**MINERALS PROGRAM INSPECTION REPORT**  
**PHONE: (303) 866-3567**

<b>MINE NAME:</b> Brann Pit	<b>MINE/PROSPECTING ID#:</b> M-1984-136	<b>MINERAL:</b> Sand and gravel	<b>COUNTY:</b> Prowers
<b>INSPECTION TYPE:</b> Monitoring	<b>INSPECTOR(S):</b> Amy Eschberger	<b>INSP. DATE:</b> March 26, 2019	<b>INSP. TIME:</b> 15:10
<b>OPERATOR:</b> Prowers County	<b>OPERATOR REPRESENTATIVE:</b> Mark Dorenkamp	<b>TYPE OF OPERATION:</b> 110c - Construction Limited Impact	
<b>REASON FOR INSPECTION:</b> Normal I&E Program	<b>BOND CALCULATION TYPE:</b> None	<b>BOND AMOUNT:</b> \$0.00	
<b>DATE OF COMPLAINT:</b> NA	<b>POST INSP. CONTACTS:</b> None	<b>JOINT INSP. AGENCY:</b> None	
<b>WEATHER:</b> Clear	<b>INSPECTOR'S SIGNATURE:</b> 	<b>SIGNATURE DATE:</b> June 7, 2019

**Prowers County  
Brann Pit  
Pre-Mining, Mining & Reclamation Plans**

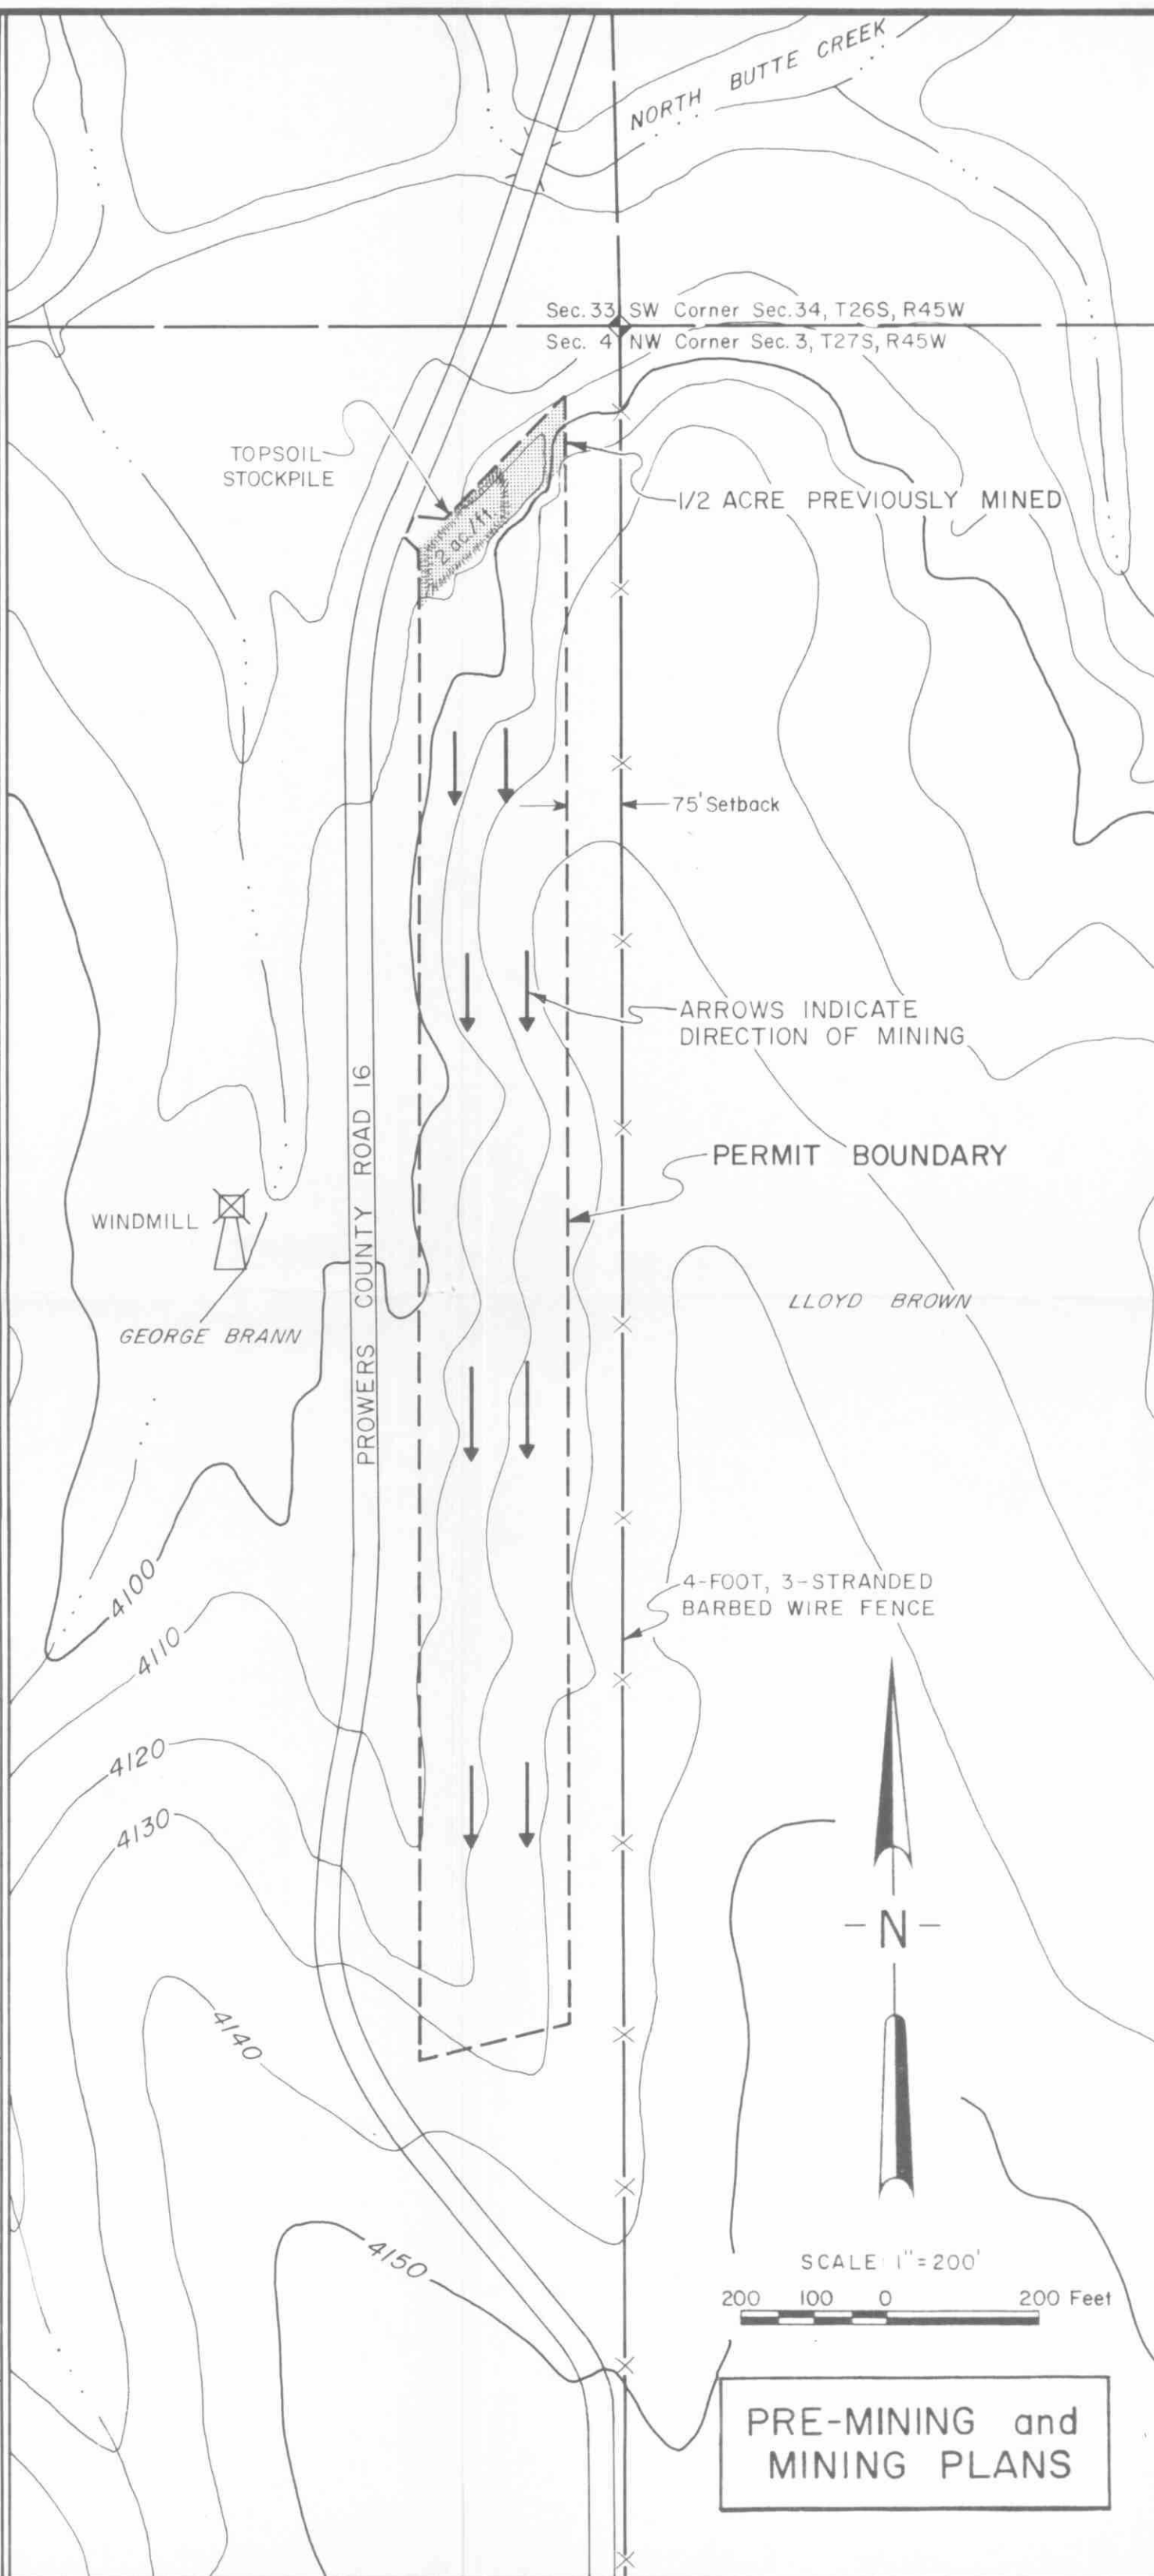
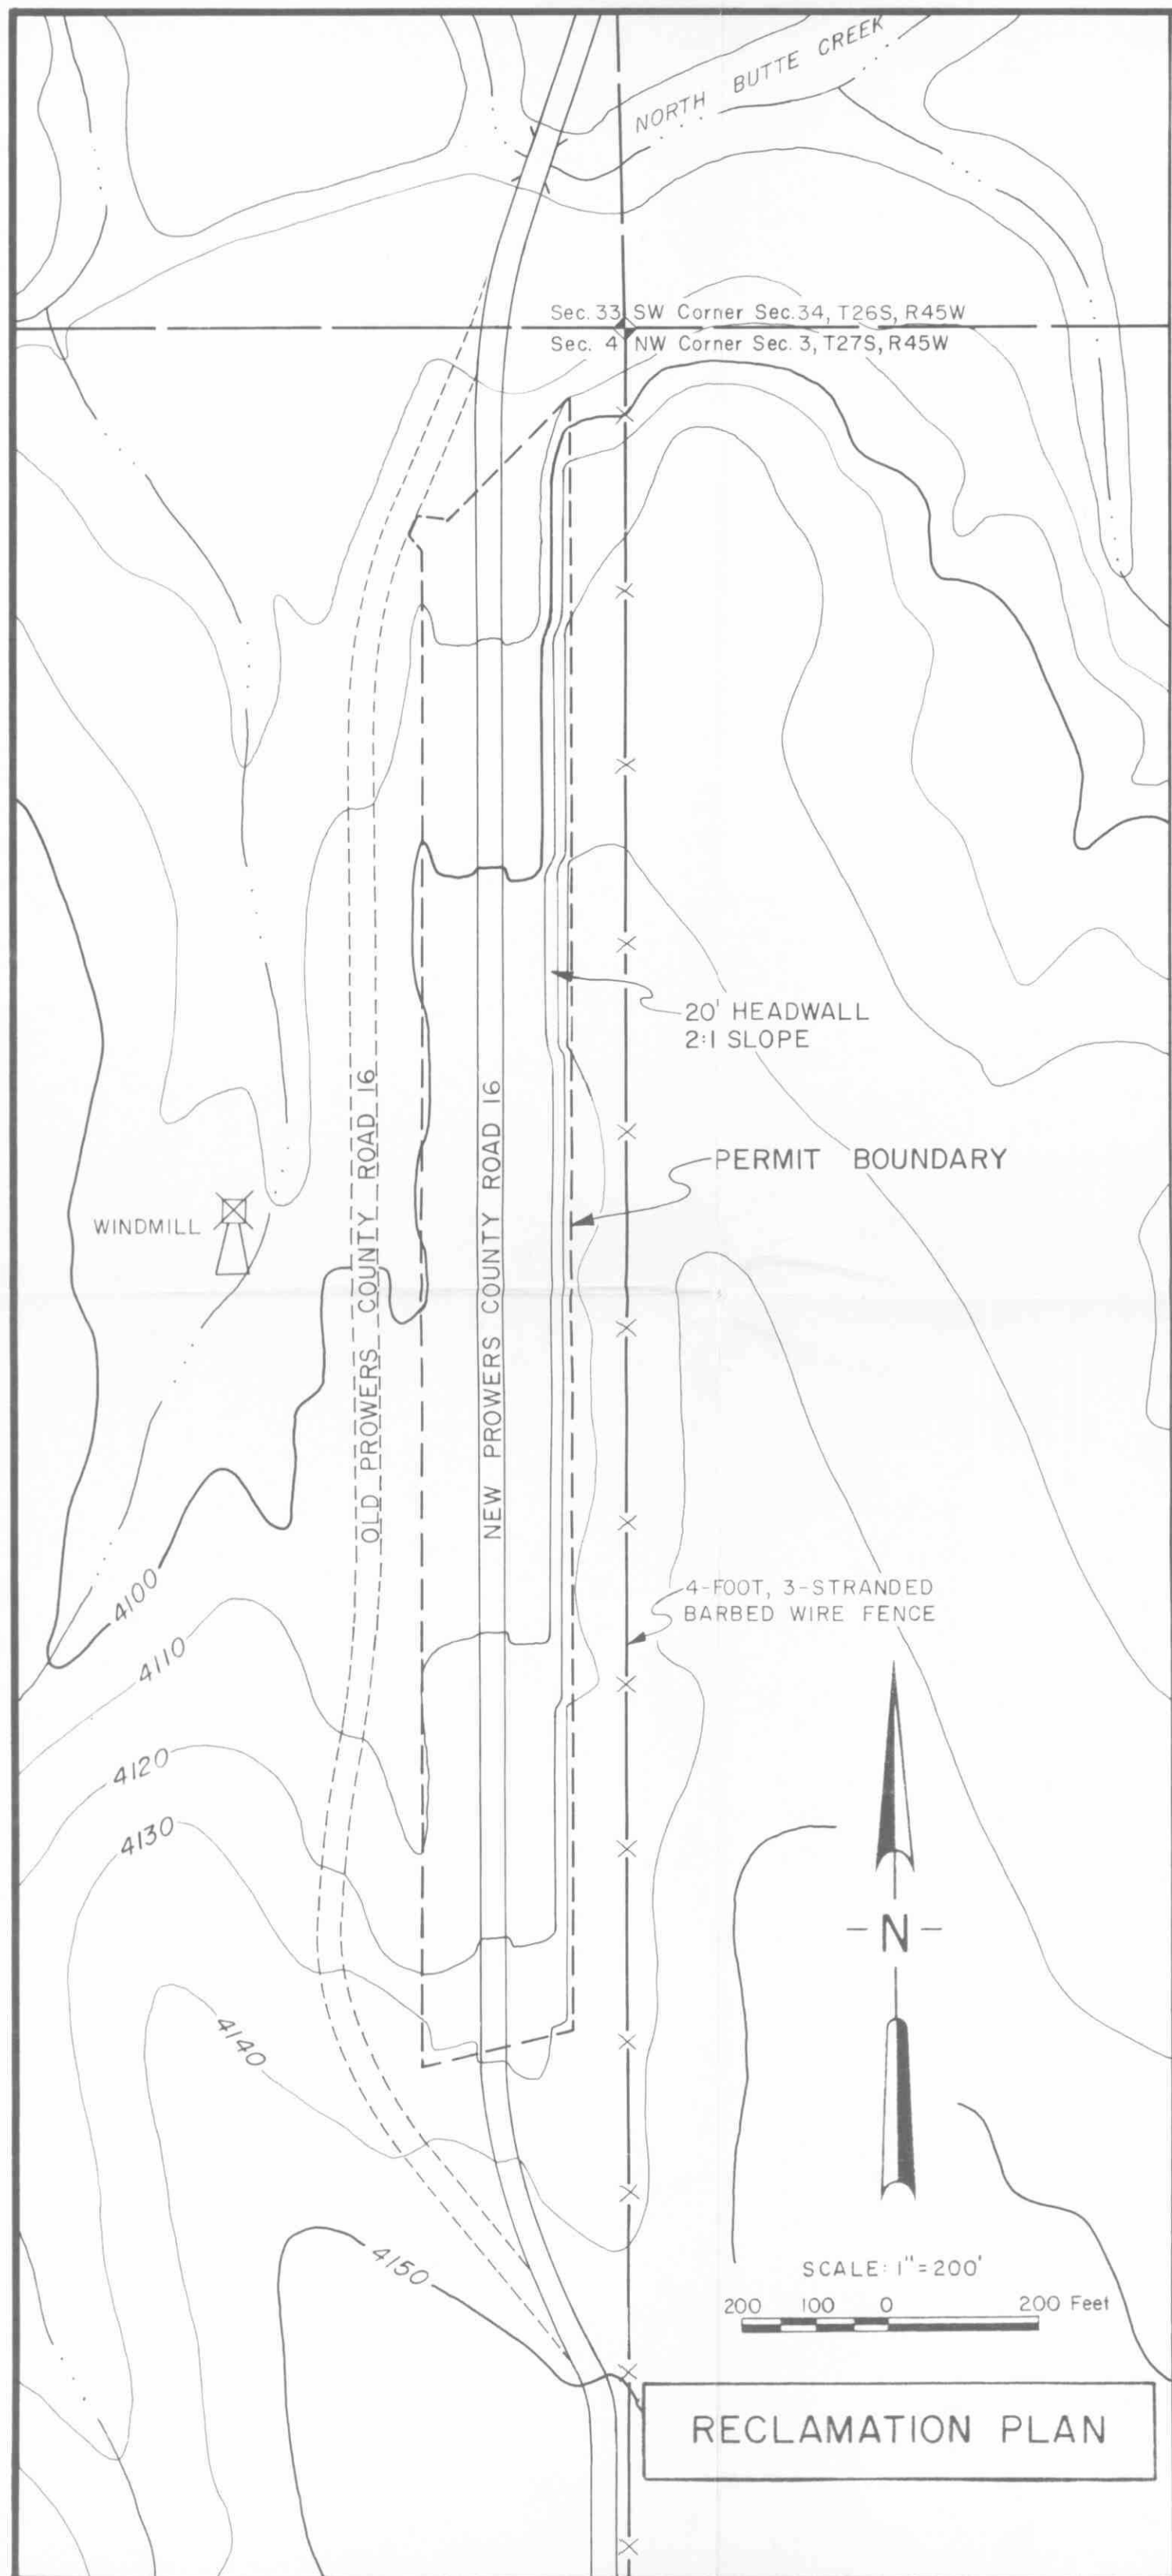
is not appropriate. In this case, the operator will need to begin final reclamation of the site in accordance with Rule 3.1.3, which requires final reclamation be completed within 5 years of completion of mining. During the inspection, Mr. Dorenkamp indicated the county may no longer need to straighten out the county road. If this is the case, the operator will need to submit a Technical Revision (form enclosed) to revise the approved reclamation plan and reclamation plan map accordingly.

The Division also discussed with Mr. Dorenkamp the reclamation plan for the highwall, which requires a final slope configuration of 2H:1V. To cut and fill the highwall for reclamation, the operator will need at least 40 feet of room to the east to lay the 20 foot highwall back to a 2H:1V slope gradient. At this time, the edge of the highwall varies from approximately 55-165 feet from the eastern permit boundary, which would allow sufficient room to cut and fill the highwall for reclamation. If the operator prefers to backfill the slopes instead of using the cut and fill method, the backfill material could potentially be obtained on site by mining portions of the highwall where there is more space between it and the permit boundary. To import backfill material to the site for reclamation, the operator would need to submit a Technical Revision for Importation of Inert Fill (form enclosed).
